Applicant: Robert H. Osborn Jr.
Application Serial No.: 10/803,642
Filing Date: March 18, 2004
Docket No.: 577-596
Page 6

REMARKS

FIG. 1

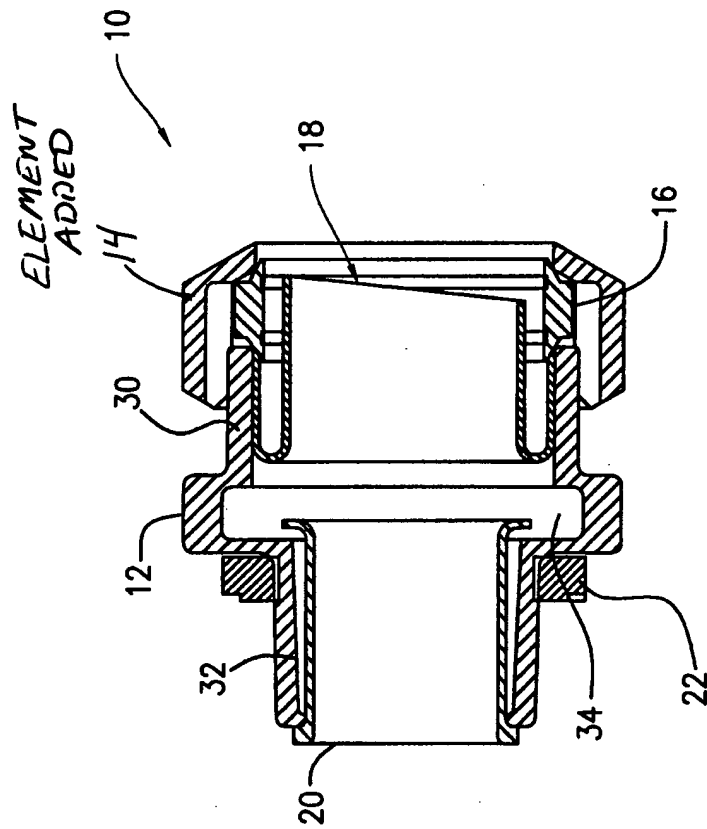
The Examiner has objected to the drawings under 35 U.S.C. §1.83(a). The Examiner contends that the gland nut as well as the sealing ring interposed between the gland nut and the body must be recited in claim 1. The Examiner suggests showing a reference numeral for the gland nut on the drawing.

The Examiner has rejected claims 1-11 under 35 U.S.C. §112, second paragraph, as being indefinite. The Examiner contends that in claim 1, line 5, "a sealing ring interposed between said gland nut and said body" is confusing because it is not shown in the drawings.

Enclosed herewith is a proposed drawing change to Figure 1. Subject to the approval of the Examiner and upon an indication of allowable subject matter, formal drawings will be prepared incorporating the proposed change. As can be seen in the attached drawing, the gland nut 14 is now properly labeled. Also as can be seen, sealing ring 16 is shown clearly interposed between gland nut 14 and body 30. It is believed that the Examiner's objection to the drawings are obviated by the proposed drawing change. Reconsideration is respectfully requested.

In view of the drawing correction submitted herewith, this determination is respectfully traversed. Reconsideration is respectfully requested.
